Interactive comment on “Assessing the potential hydrological impact of the Gibe III Dam on Lake Turkana water level using multi-source satellite data” by N. M. Velpuri and G. B. Senay

Author’s Response to Referee Comment #2 by Dr. Micha Werner

Fig. 1. Figure. Monthly calibration coefficients derived for Gibe I, Gibe III and Turkana basin runoff.

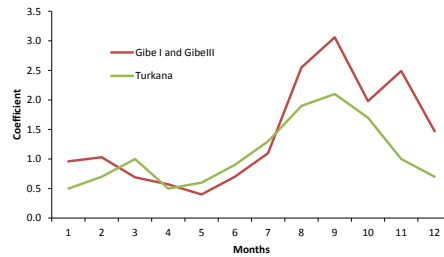
14. P3005 L2-10: An initial error of 49% seems to be quite significant. Again the role of the evaporation data in this should be included in the discussion. Given this quite large bias – it may be interesting to look at the range of values of the multiplier for each month that has been calibrated, and discuss if these are realistic (e.g. is there consistency between wet/dry season corrections, or is there no serial correlation between months?).

Response: The issue of error/bias in RFE and the role of ET data will be addressed by the inclusion of a new section on uncertainty in the revised manuscript. The range of values of the multiplier used for calibration of runoff are analyzed and presented in figure 1.

We believe that the multiplier values are reasonable and realistic. These values are within the bounds of errors observed in the satellite based rainfall estimates (RFE data). It has to be noted that RFE underestimates up to 50% in general and the multiplier values are thus with the maximum value of 2.0 for Lake Turkana inflows. Also, please

note that multiplier values for Gibe III are little higher. This is because Gibe-III basin falls in the mountainous region where orographic rainfall is common. As RFE also underestimate orographic rain, the multiplier values are little higher over the peak rainy month. The multiplier values demonstrate seasonality and serial dependence on a monthly time-scale. We will discuss and modify section 3.2.2 in the revised manuscript as suggested by the reviewer.
